SERVICE BULLETIN

MODEL: 300

BULLETIN NO: 4

ADJUSTMENT OF AC SOLENOIDS ON RECORDERS BELOW SER. NO. 500

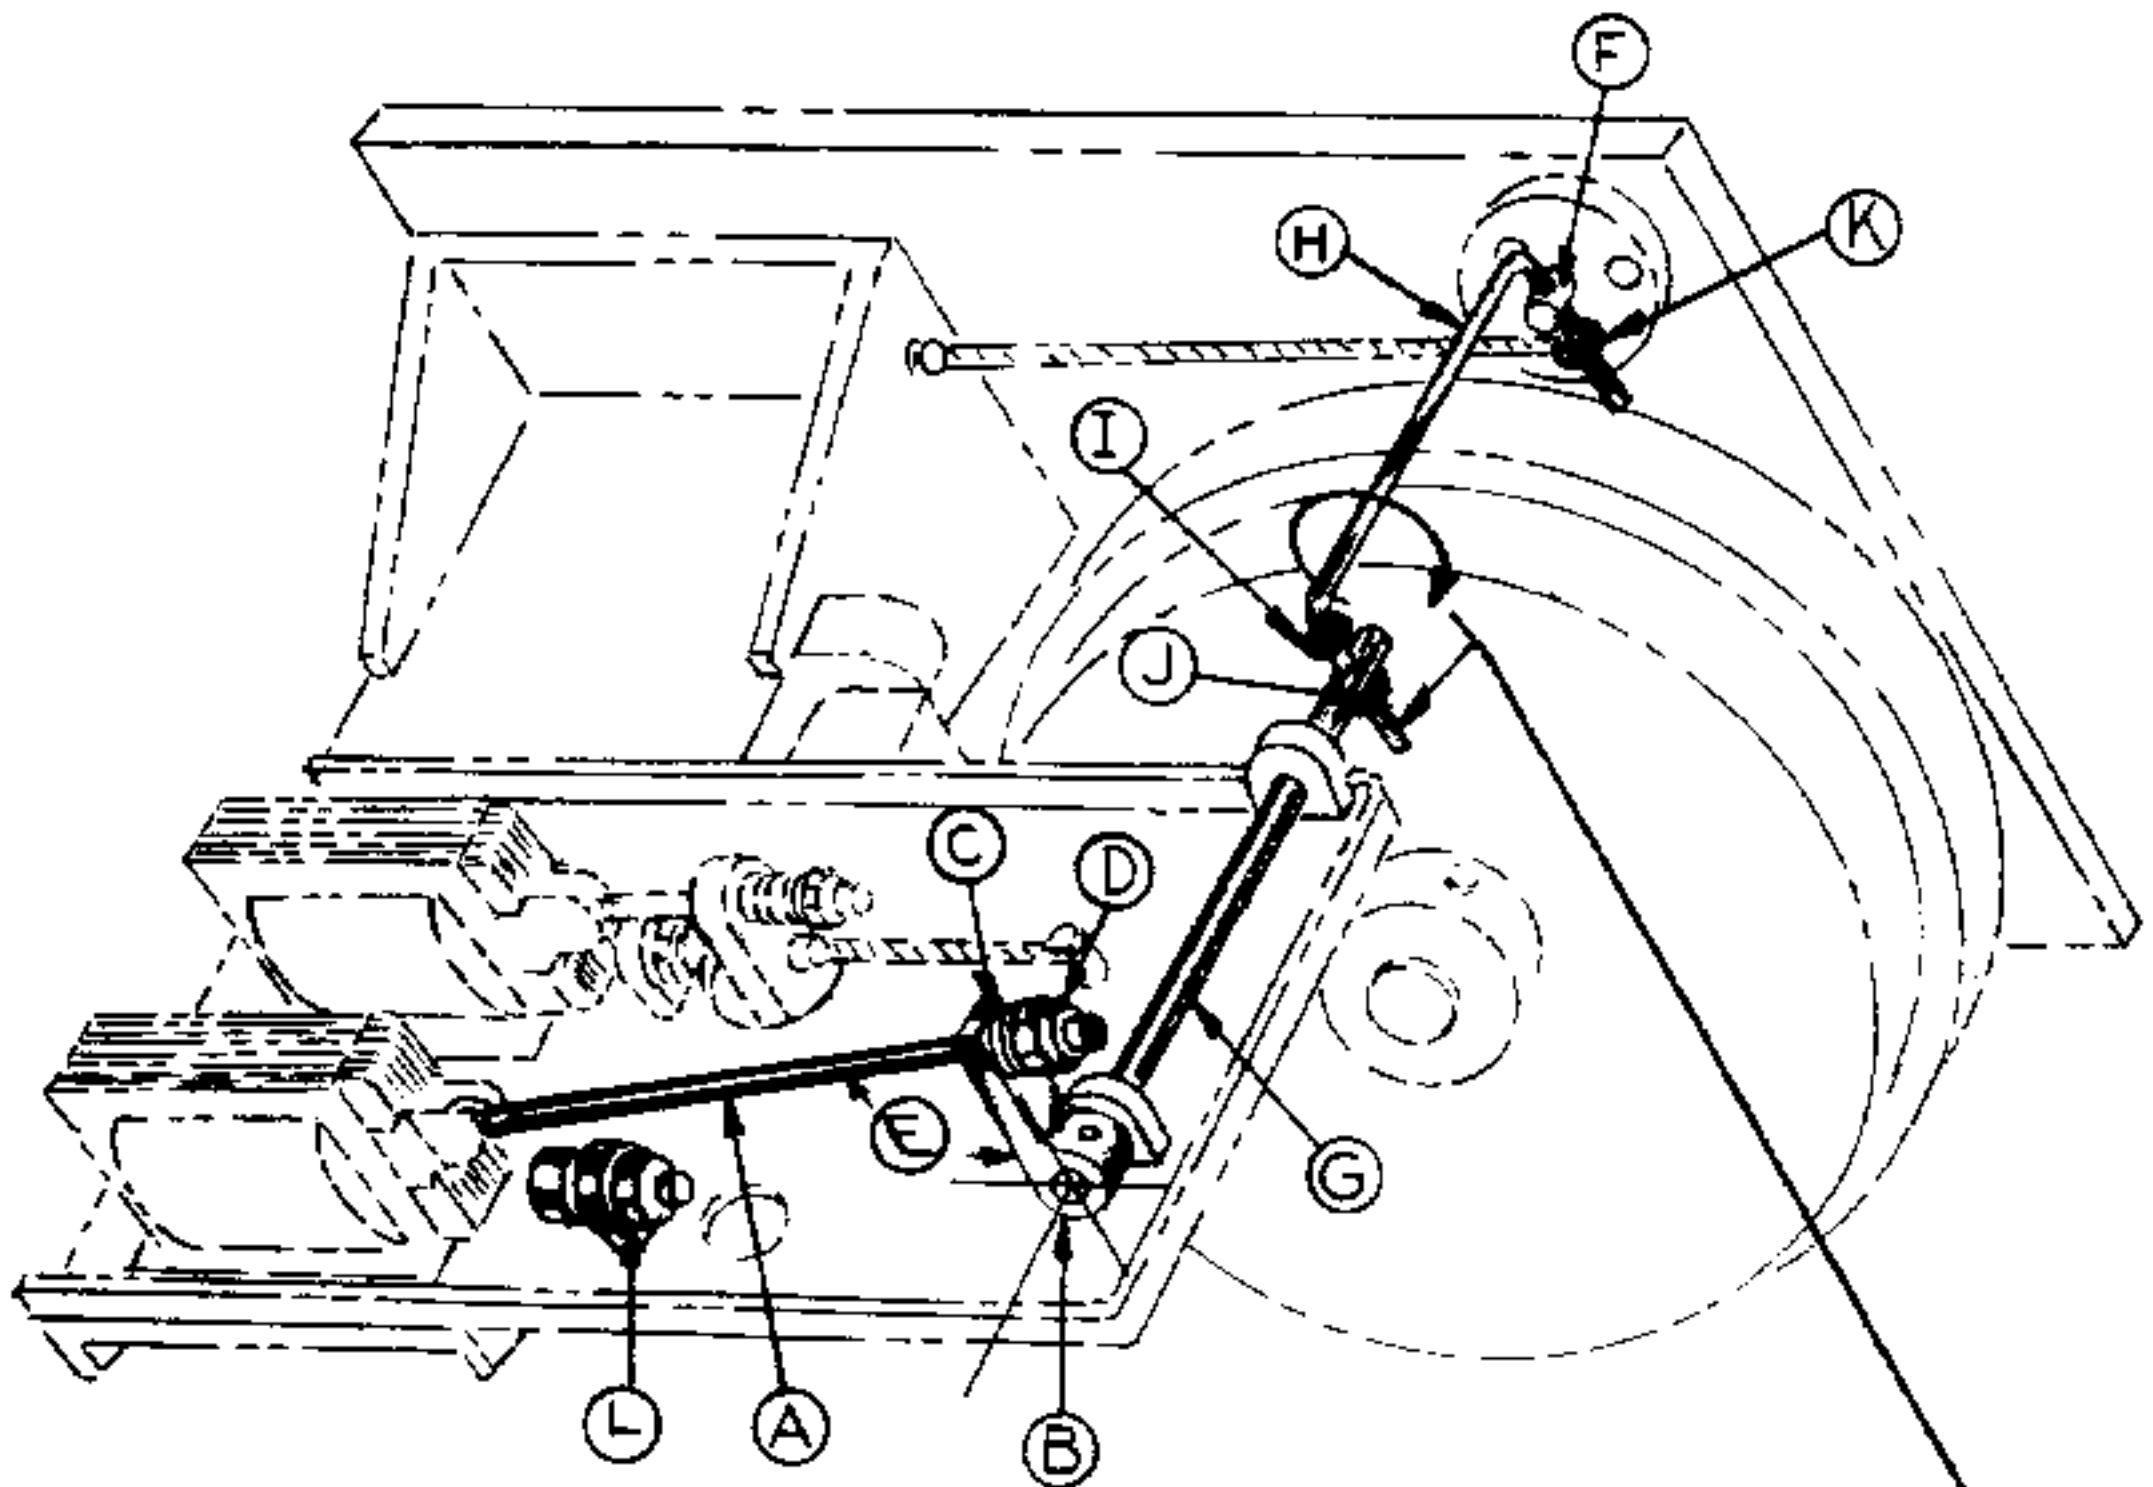
Some difficulty has been experienced with the humming or buzzing of the solenoid which operates the capstan idler, E801. Investigation of the cause of this noise has disclosed that if the linkage has not been adjusted properly, the force required of the solenoid will be greatly increased and therefore cause it to hum.

Looking at the drive assembly from the bottom, the linkage of the capstan idler solenoid can be seen. The link rod A passes through a hole in the arm B that it operates, and there is a rubber washer (C) and adjusting nut (D) on the end. When the solenoid is operated, the rod pulls the rubber washer against the arm to operate it. When the solenoid is seated, the angle E between the rod and the arm should be less than 90° . If this is so, the effective contact point of the washer is on the outside. If the angle between the rod and the arm is greater than 90° when the solenoid is seated, the contact point of the washer on the arm is on the inside, effectively reducing the moment arm by a considerable amount, and therefore requiring much greater force to be exerted by the solenoid.

The importance of maintaining the above angle E below 90° was only recently discovered, and it is possible that some machines have been shipped in which this angle might be too great. While no machines have been shipped with noisy solenoids, it is possible that if the above adjustment is not proper the solenoids may become noisy in use. Should this be the case, the adjustment can be corrected as follows:

TO REDUCE ANGLE E, BEND
THIS ARM CLOCKWISE WITH
RESPECT TO UPPER ARM. RESET
ADJUSTING NUT D & L.

ANGLE E MUST BE LESS THAN 90° WHEN
CAPSTAN SOLENOID IS SEATED.

It will be noted that the capstan idler arm shaft F is connected to the operating shaft G below through a U-shaped torque link H. If the bottom (or shorter) arm of this link H is bent in a clockwise direction (when looking at the link from the bottom or short arm end), this will effectively reduce the angle E. In order to bend this arm, it is necessary to remove link H and hold it in a vice. The link can be removed by forcing off the spring-lock washers which position the lower arm (I and J) and which attach the return spring at the top (K). The proper value for the angle E is approximately 85° , or when the arm H is perpendicular to the plane of the solenoid base plate.

If the angle E is changed, it will be necessary to re-set the capstan idler adjustment D. This adjustment is set so that when the capstan idler just touches the capstan, the solenoid is $1/8$ inch shy of seating. A simple way of making this setting is to place a piece of material $1/8$ inch thick between the solenoid armature and body and clamp the armature down on it. Then tighten the nut D until the capstan idler just touches the capstan.

It may also be necessary to reset the capstan idler solenoid Stop L. This stop should be set so that at no time during fast winding does the tape touch the capstan idler.
